SEWAGE DISPOSAL SYSTEM

DEPARTMENT OF HEALTH AND MENTAL HYGIENE

SUBDIVISION West Friendship Estates LOT 94 ROAD 3313 Fox Valley Drive

Howard County Department of Health
 BUREAU OF ENVIRONMENTAL HEALTH
RECORD OF INVESTIGATION

Lot 94 West FRIENDSHIP EST.
3313 Fox Valley DR.

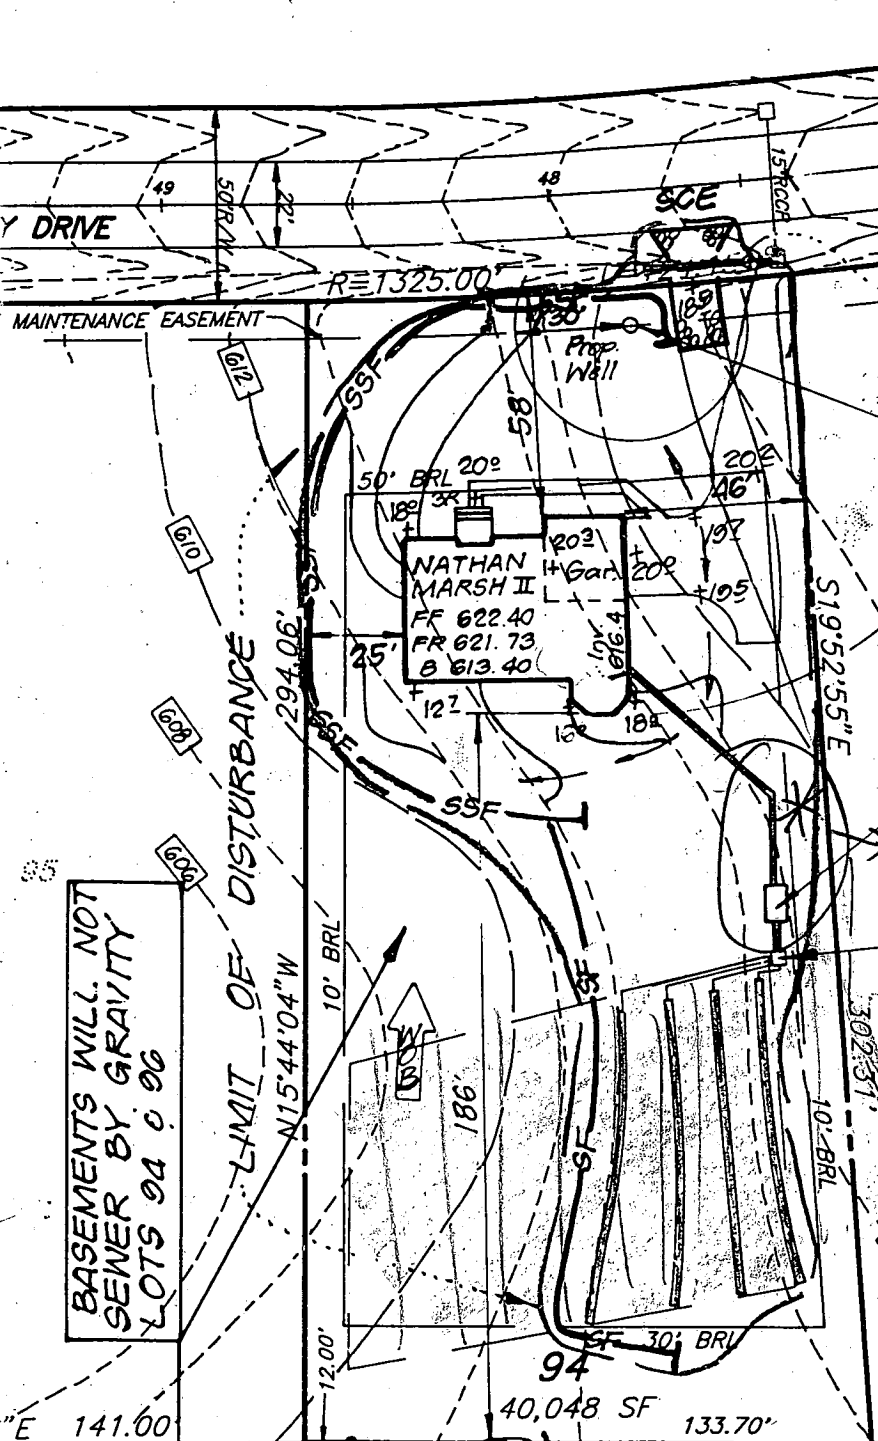
PREFER SEPTIC TANK BE INSTALLED
BEFORE BEND. (CW)
Distribution Box Stone
Ex. Grd. 617.5
Inv. 616.5

BASEMENTS WILL NOT
SEWER BY GRAVITY
LOTS 94 & 96
